Libas Textiles Ltd. (New building)

10th July & 5th August 2019

Observations

Discrepancies between as-built drawings and on-site observation

C-4 type column

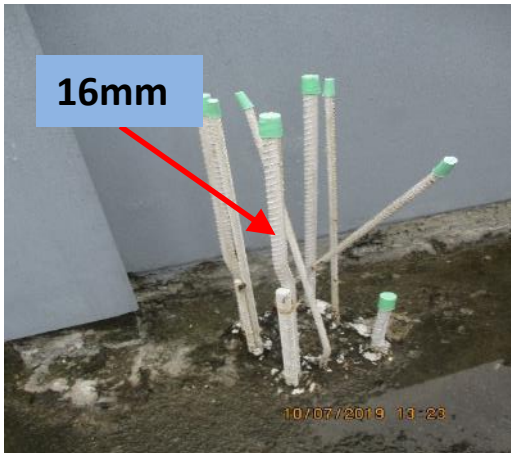
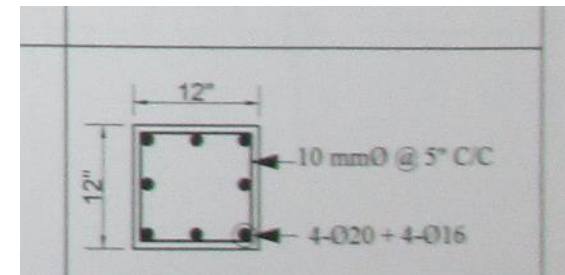
4 nos. 16 mm and 4 nos. 12 mm rebars were found on site in C-4 type column

4 nos. 20mm and 4 nos. 16mm rebar were shown in column schedule for C-4 type column at roof

Typical Beam Layout Plan

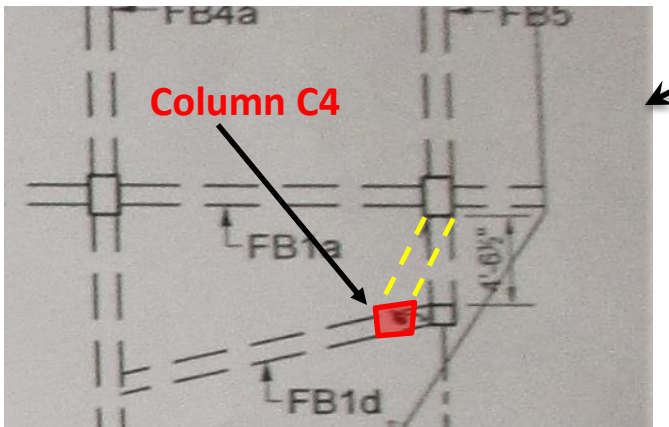
Beam FB5 was found offset towards west from grid I2'.

Water ingress through cracks on slab

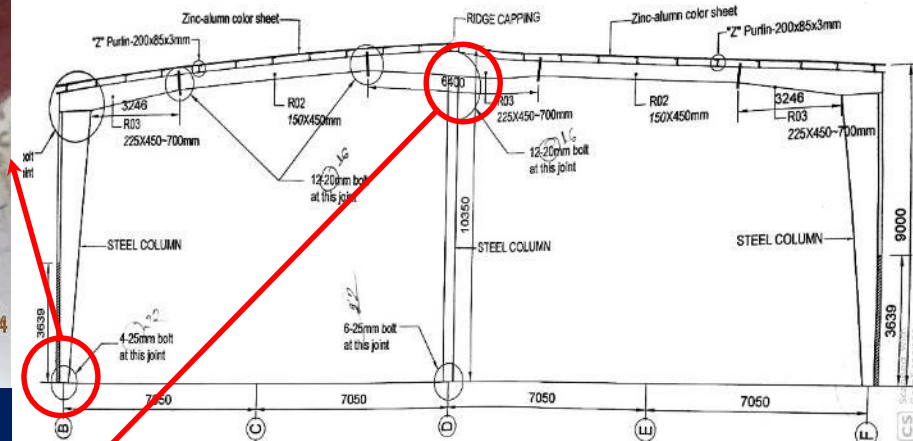
Hairline cracks were observed on slab soffit (cantilever region) and on several floor beams. Sign of water ingress through the cracks on the roof slab was observed.

| Item No. | Observation | Recommended Action Plan | Recommended Timeline |
|----------|---|--|----------------------|
| 5 | Cracks found under slab soffit & beam (Building-4) | Crack investigation report is required to be prepared stating the nature of crack and suggesting proper remedial measures. | 6-weeks |
| 6 | Cracks found under slab soffit & beam (Building-4) | Repair cracks as per recommendation of investigation report. | 6-months |

Section drawing

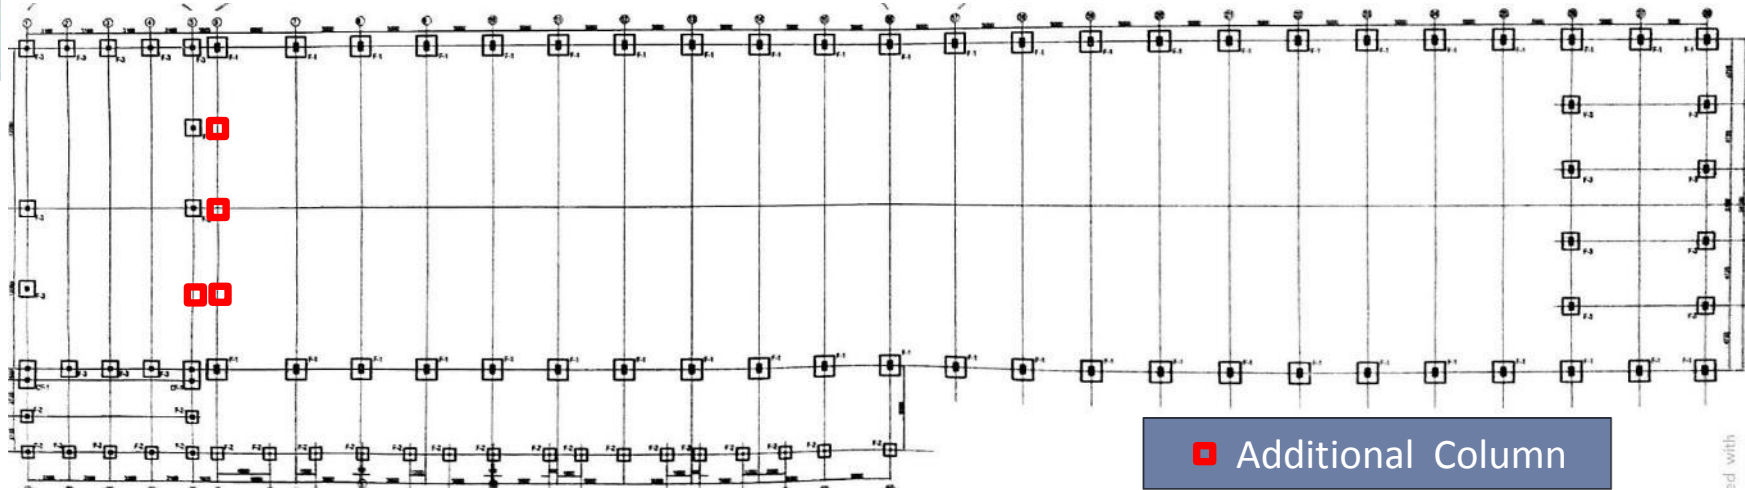
Anchor bolts were 22 mm instead of 25 mm as mentioned in provided as-built drawings.

Column-rafter joint has 16-16 mm bolts and rafter-rafter joint has 12-16 mm bolts instead of 16-20 mm bolts as mentioned in as-built drawings

Connection and anchor bolt details provided in as built drawing did not match with on site condition.
Bracing layout or bracing details wasn't incorporated in the as-built drawings.

Column layout plan

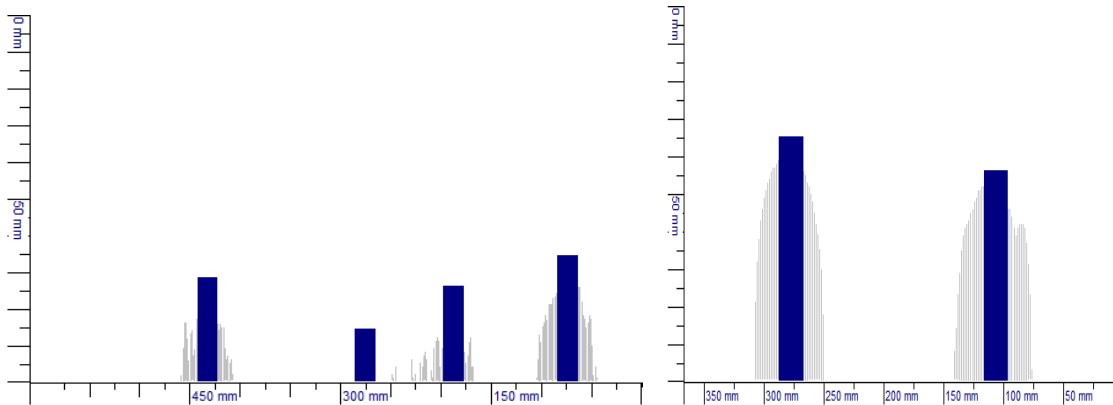
8-20 mm rebars were found in C1 type columns instead of 12-20 mm rebars.

Number of reinforcement mentioned in the as-built drawing was not representative of on site condition. Column layout also did not match with the drawing.

| Item No. | Observation | Recommended Action Plan | Recommended Timeline |
|----------|--|--|----------------------|
| 7 | Incomplete as-built drawings. (Dyeing Shed) | Building Engineer to survey the whole structure and prepare accurate as-built drawings representing actual on-site condition. | 6-weeks |

Column layout plan

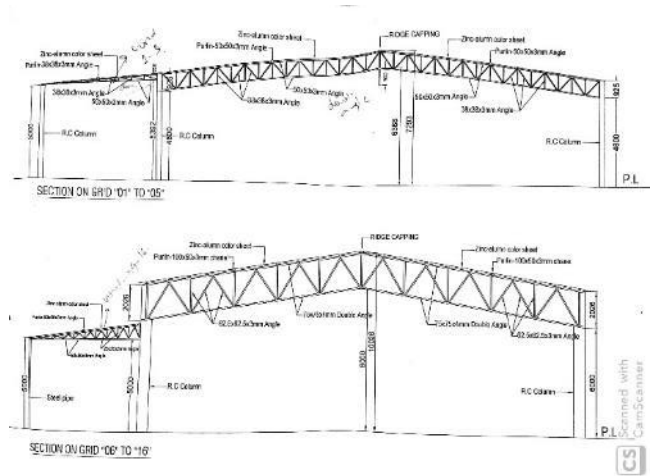
Extension part of the shed mentioned in the drawing

Extension part in western side of the shed shown in the as-built drawing was not representative of on site condition. There was also an undocumented extension part of the shed.

No connection detail of the RC column and steel truss was incorporated in the as-built drawing

Bracings in old part of the Dyeing Shed

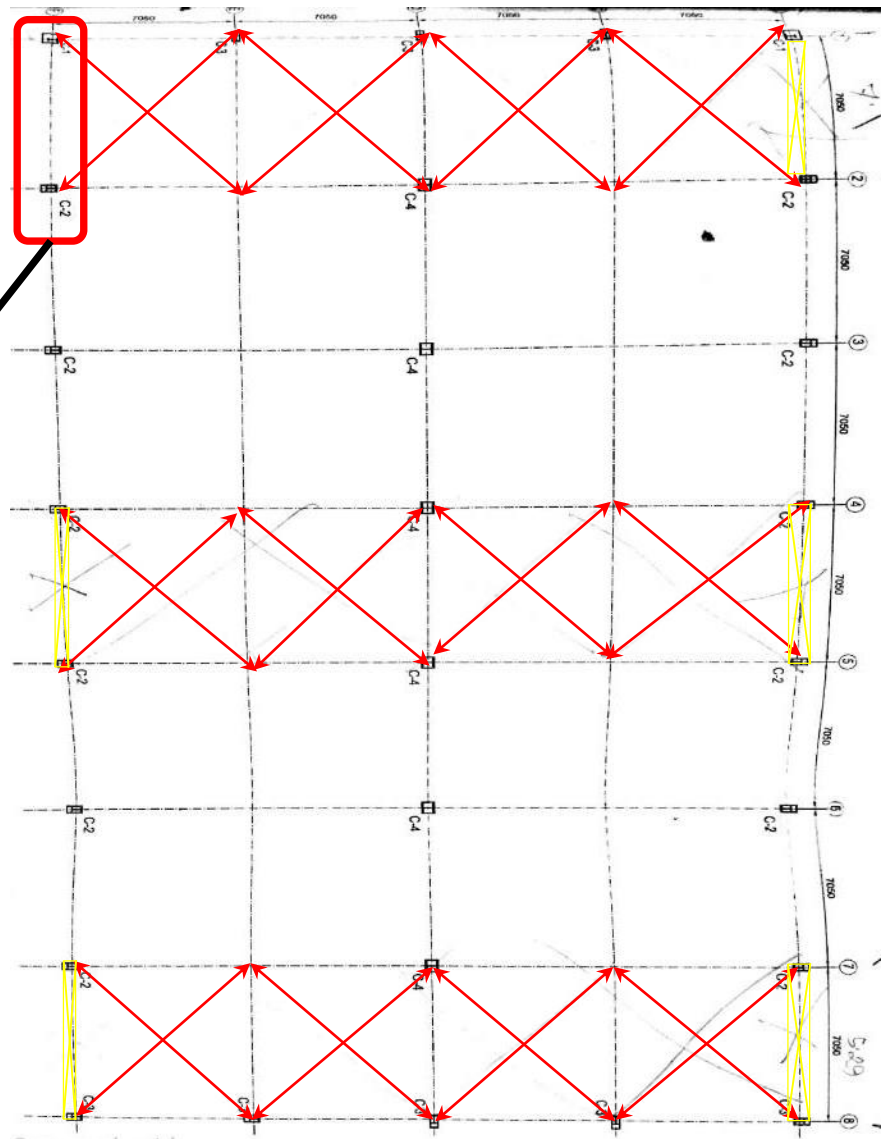
The ridge height is 10 m and the roof slope is quite steep. The continuous load transfer media along the long direction of roof is apparently missing. Vertical bracings between the trusses appeared to be inadequate against lateral loading. Moreover, no bracing layout or bracing details was incorporated in as-built drawings. Building engineer is required to review the design consideration and requirement of bracing system against lateral loading.

| Item No. | Observation | Recommended Action Plan | Recommended Timeline |
|----------|--|--|----------------------|
| 10 | Apparent lack of lateral stability (Dyeing Shed) | Building Engineer to check the stability of the structure against lateral loading. Also review the bracing system of existing structure. | 6-weeks |

Loose vertical bracing

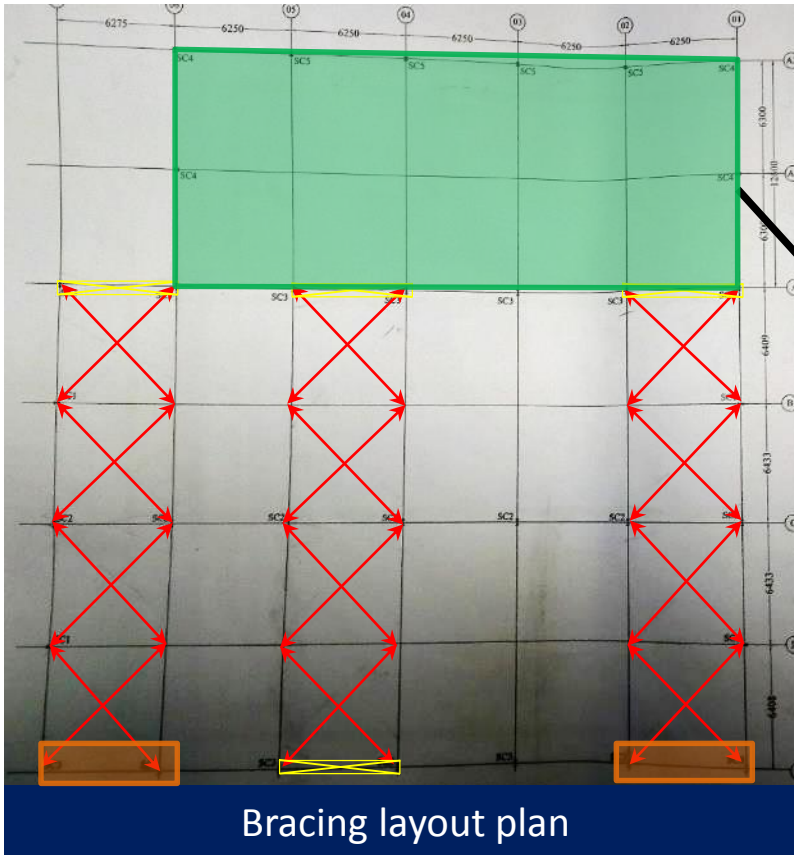
Horizontal roof bracings and vertical bracings were found loose.

| Item No. | Observation | Recommended Action Plan | Recommended Timeline |
|----------|---|---|----------------------|
| 24 | Loose cable bracings (Dyeing Shed) | Building Engineer to survey the whole structure and tighten loose bracings where necessary. | 6-weeks |

Bracing layout plan

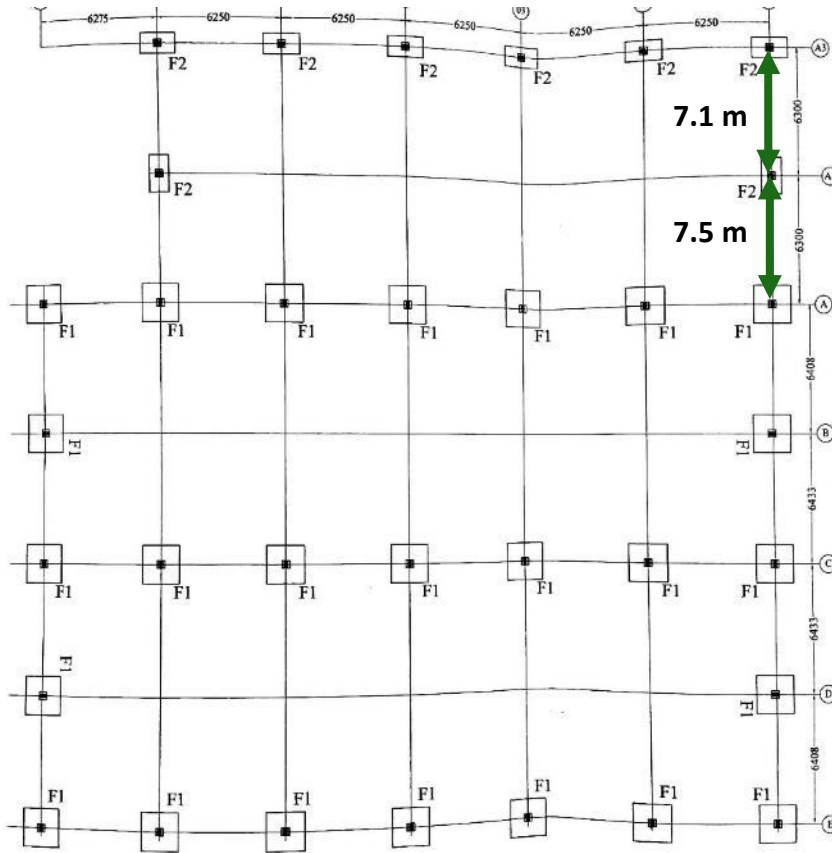
No vertical bracing was found at Grid E between 1 & 2 and 6 & 7. Bracing from this location was removed due to exit placement. Moreover, there were no bracing in the marked region of the shed.

No roof bracing was observed in this part

| Item No. | Observation | Recommended Action Plan | Recommended Timeline |
|----------|---|---|----------------------|
| 25 | Wall bracing missing in long direction (Finished Goods Store) | Building engineer is required to check the existing bracing system of the structure and requirement of bracing for stability. | 6-weeks |

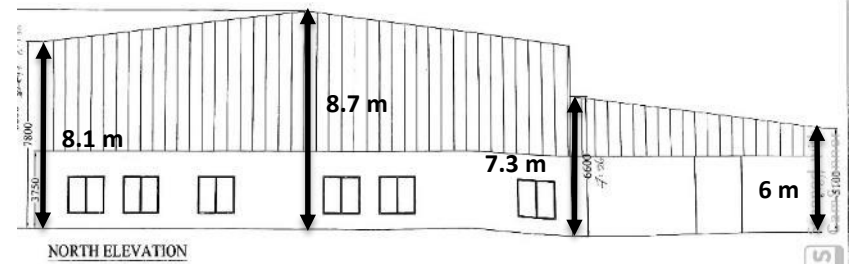
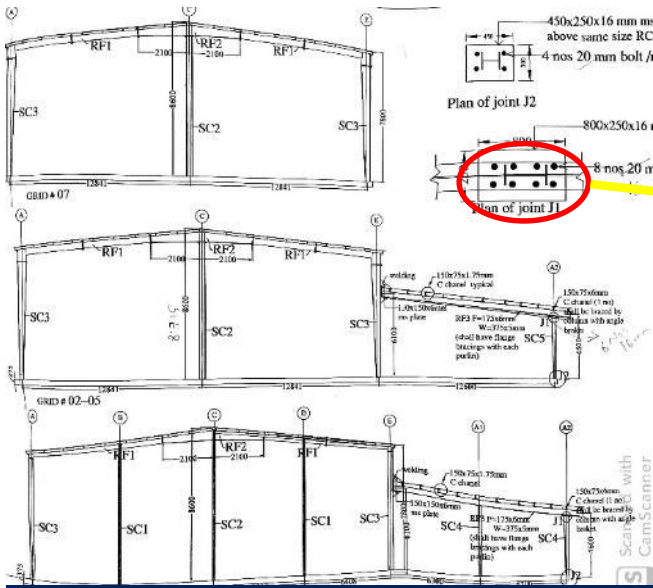
Grid dimension mentioned in the provided as built drawing (Shown on the layout) does not match the on site condition.

Section height mentioned in the provided as built drawing (Shown on the layout) does not match the on site condition.

Building Engineer is required to survey the whole structure to prepare accurate as-built drawings with actual dimension.

| Item No. | Observation | Recommended Action Plan | Recommended Timeline |
|----------|---|---|----------------------|
| 27 | Incomplete as-built drawings and connection adequacy check (Finished Goods Store) | Building Engineer to survey the whole structure and prepare accurate as-built drawings. | 6-weeks |

Section drawing

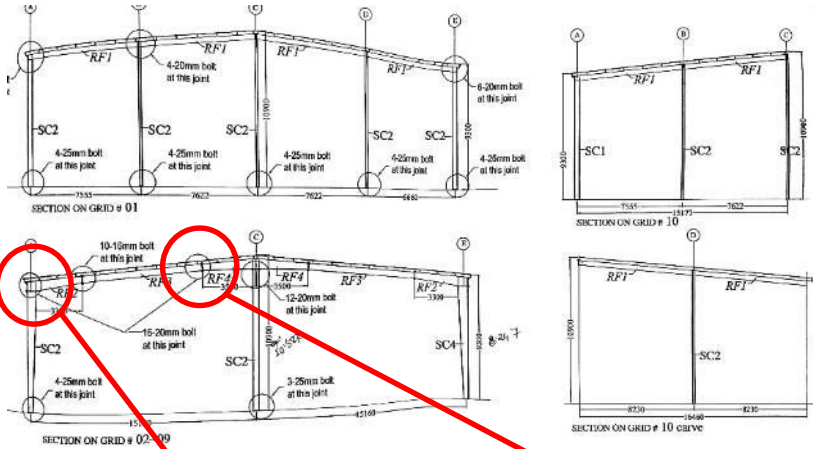
Joint J1 has 8-16 mm bolts instead of 8-20 mm bolts as mentioned in as-built drawings

Connection detail was not provided for rafter-rafter joint between grid A to A2

Connection detail for any of the joints was not provided between grid A to E.

No connection details or anchor bolt details was incorporated in provided as-built drawings for joints between grid A to E. Moreover, connection details for grid A to A2 were not complete. Building engineer is required to check for connection adequacy.

| Item No. | Observation | Recommended Action Plan | Recommended Timeline |
|----------|---|---|----------------------|
| 28 | Incomplete as-built drawings and connection adequacy check (Finished Goods Store) | Building engineer to check adequacy of the connections. | 6-weeks |

Section drawing

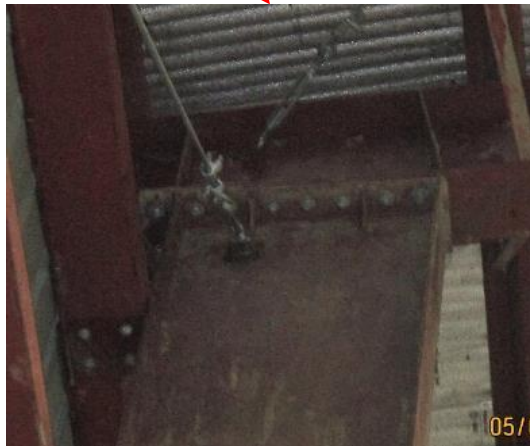
Anchor bolts were 20 mm instead of 25 mm.

Column-rafters joint has 16-16 mm bolts and rafter-rafters joint has 12-16 mm bolts instead of 16-20 mm bolts as mentioned in as-built drawings.

No connection details was provided for Grid 10. Anchor bolt details were not matched with provided drawing. Building engineer is required to survey the whole structure to prepare accurate as-built drawings with actual dimension. Also building engineer is required to check for connection adequacy.

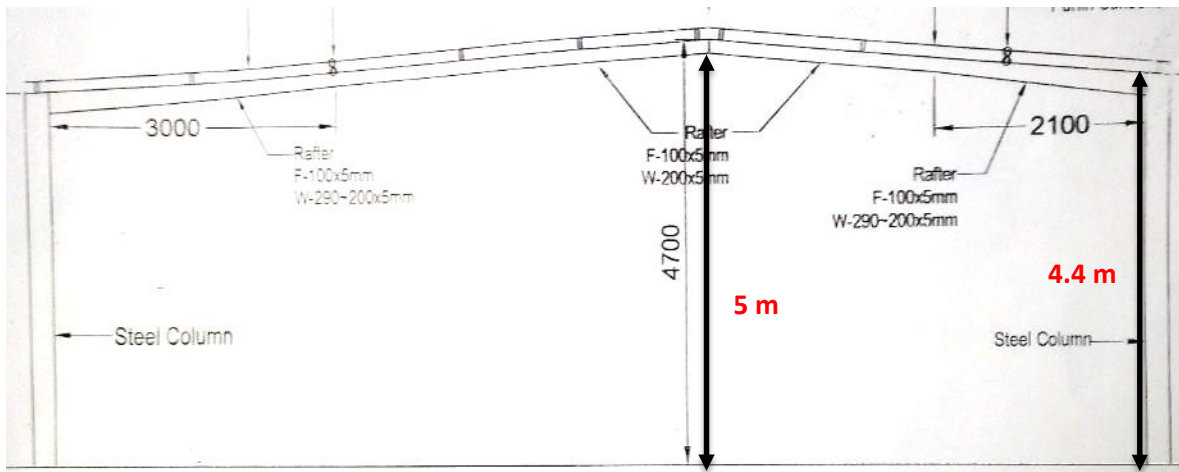
No apparent stability system (bracing, strut) was observed against lateral loading

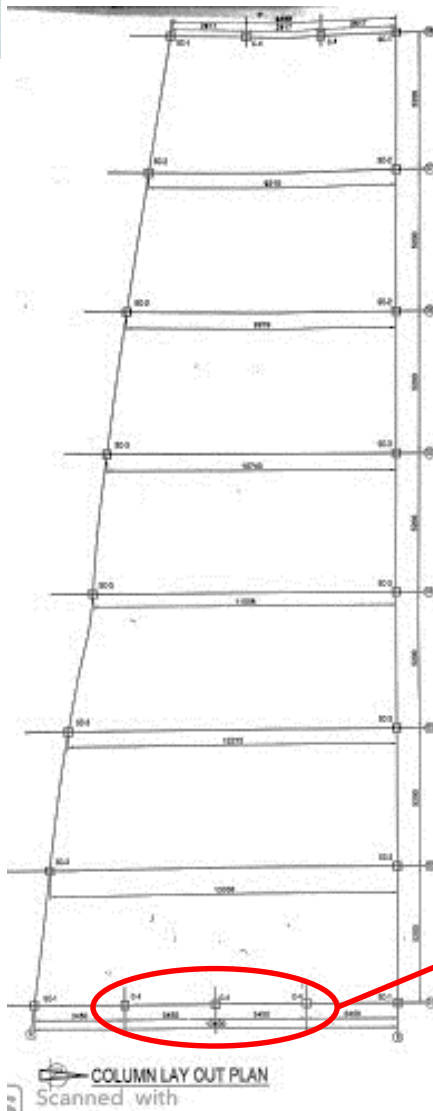
Existence of significant gap was observed between column-rafter and rafter-rafter connections at several locations.

| Item No. | Observation | Recommended Action Plan | Recommended Timeline |
|----------|--|---|----------------------|
| 46 | Existence of significant gap between connections. (Batch Store) | Building engineer to survey the whole structure to locate the gap in joints and take suitable measures. | 6-weeks |
